# Access Compliance Report

## Public Rights-of-Way

Intersection ID: 12475	Main Street: AIRPORT_CENTER_PY	Cross Street: GOLF_ACRES_DR	Location: NW
ADA ID: BF597E8DF794	Ramp Type: PerpDiag	Initial Pass/Fail: Fail	Overall Compliance: No
Codes/Mitigation Info/Possible Solution		Field Measurements/Component Compliance	
Severity Score: 46.25

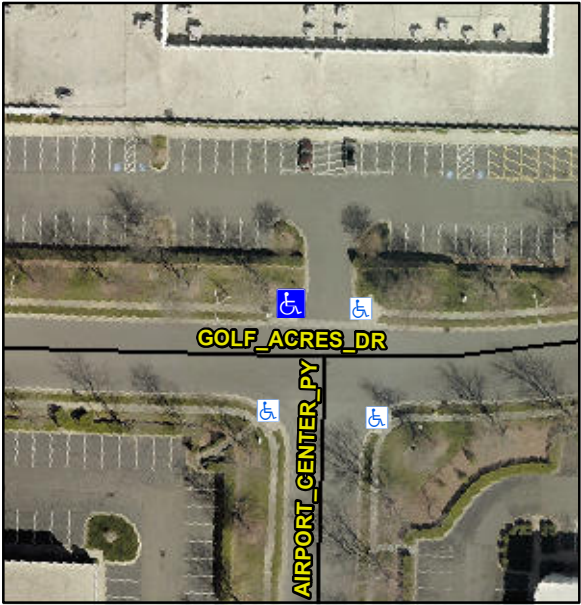
Possible Solutions:				
	Remove & Replace Curb Ramp With Two New Directional Ramps or Equivalent.				
	Surveyor Notes:				
	N/A				
	PROW/ADA:				
	R304.5.1, R304.2.2, R304.5.3				
Street 1 Name	GOLF ACRES DR				
Stop Condition-Street 2	None				
Street 2 Name	AIRPORT CENTER PY				
Stop Condition-Street 1	StopSign				
Total Cost:		\$	3200.00

Compliance	Description	Data	Compliance	Description	Data
N/A	Ramp Length (in)	104.0	No	Ramp Slope (%)	9.0
No	Ramp Width (in)	38.0	No	Ramp XSlope (%)	14.9
N/A	Flare Type LT	N/A	N/A	Flare Type RT	N/A
N/A	Flare Slope LT (%)	N/A	N/A	Flare Slope RT (%)	N/A
N/A	Flare Traversable LT?	N/A	N/A	Flare Traversable RT?	N/A
N/A	Landing Length (in)	N/A	N/A	DWS Provided?	N/A
N/A	Landing Width (in)	N/A	N/A	DWS Contrast?	N/A
N/A	Landing Slope (%)	N/A	N/A	DWS Length (in)	N/A
N/A	Landing X Slope (%)	N/A	N/A	DWS Full Width?	N/A
N/A	Landing Curb? (Y/N)	N/A	N/A	DWS Offset (in)	N/A
N/A	Shared Landing?	N/A			
N/A	Gutter Ponding?	N/A	N/A	Gutter Slope (%)	N/A
N/A	Gutter Lip Ht (in)	N/A	N/A	Gutter X Slope (%)	N/A
N/A	Painted X Walk1?	No	N/A	Painted X Walk2?	No
	X Walk 1 Direction	To S		X Walk 2 Direction	To E
N/A	X Walk 1 Width (in)	N/A	N/A	X Walk 2 Width (in)	N/A
	X Walk 1 Slope (%)	4.0		X Walk 2 Slope (%)	0.6
	X Walk 1 X Slope (%)	2.1		X Walk 2 X Slope (%)	11.6
